Lloyd's Register of Shipping.

Ship's Name ~~TREGLISSON~~ YOUSUF BAKSH Official No. ~~183212~~
tick 7/6/60

Memorandum of alterations reported since ship was surveyed for assignment of Load Lines
in PORT GLASGOW

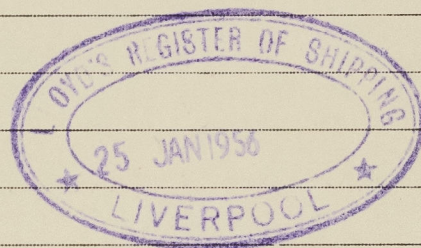
The following alterations noted at this time -

Hatches fitted to freeboard deck in way of Nos 1, 2, 3 & 4
shelter tween deck spaces, on port side adjacent to centre
line bulkhead in all cases, giving access to hold ladders.

Hatches are 42" x 36" and have a 9" x 4" x .45" bulb angle
coaming, with wood covers, cleats, battens, rest bars and
tarpaulins all to rule requirements.
